**SIB 51 18 15**

A Check Control Message is displayed for the Tailgate Lock Open

This Service Information Bulletin (Revision 1) replaces SI B51 18 15 **dated September 2015**.**What's New** (Specific text highlighted):

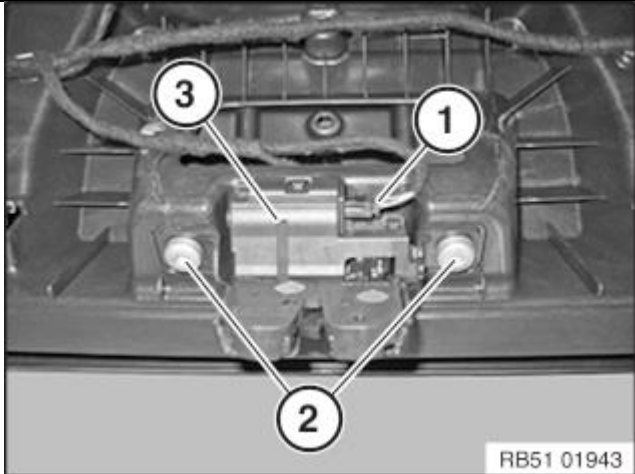
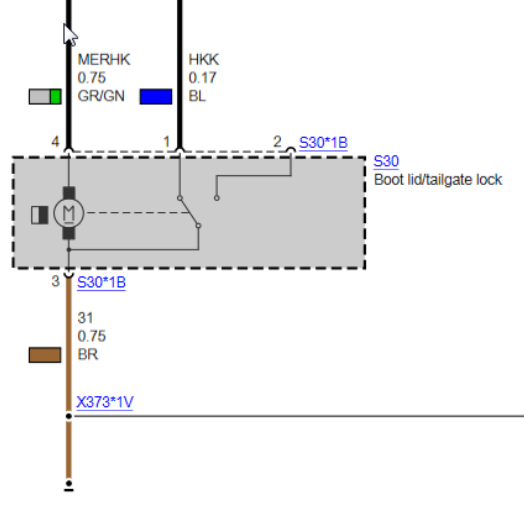
<p>The customer states that the trunk open warning is displayed, even though the trunk is mechanically closed.</p>
	<p>Check the movement of the tailgate lock in both detent positions with a pencil or similar object.</p> <p>If the movement is not smooth and the lock binds, replace the tailgate lock. Compare to a known good vehicle for reference.</p>
 <div style="display: flex; justify-content: space-around; margin-top: 10px;"> <div style="border: 1px solid black; padding: 2px 5px;">A</div> <div style="border: 1px solid black; padding: 2px 5px;">B</div> </div>	<p>The two detent positions are shown and will be referred to in the following measurements.</p> <p>A: Detent position 1</p> <p>B: Detent position 2</p>
 <p style="text-align: right; font-size: small;">RB51 01943</p>	<p>Remove the connector S30*1B (1) from the tailgate lock.</p> <p>The following measurements are taken on the tailgate lock itself.</p>

<p>1. Measure between PIN 3 and 4 (the resistance of the motor is measured)</p> <p>1<sup>st</sup> detent position: Approx. 3-4 Ohm 2<sup>nd</sup> detent position: Approx. 3-4 Ohm</p> <p>2. Measure between PIN 2 and 3 (the switch position is checked)</p> <p>Lock open: Approx. 0.8 Ohm 1<sup>st</sup> detent position: Approx. 0.8 Ohm 2<sup>nd</sup> detent position: Approx. OL or "open"</p> <p>3. Measure between PIN 1 and 3 (the switch position is checked)</p> <p>Lock open: Approx. 0 Ohm 1<sup>st</sup> detent position: Approx. 0 Ohm 2<sup>nd</sup> detent position: Approx. 0.8 Ohm</p> <p>If any measurements are not correct, replace the tailgate lock.</p> <p>If all measurements are correct, check the closing comfort of the tailgate and adjust the tailgate lock as per the Repair Instructions "51 24 004 Adjust rear lid lock".</p>
---	--
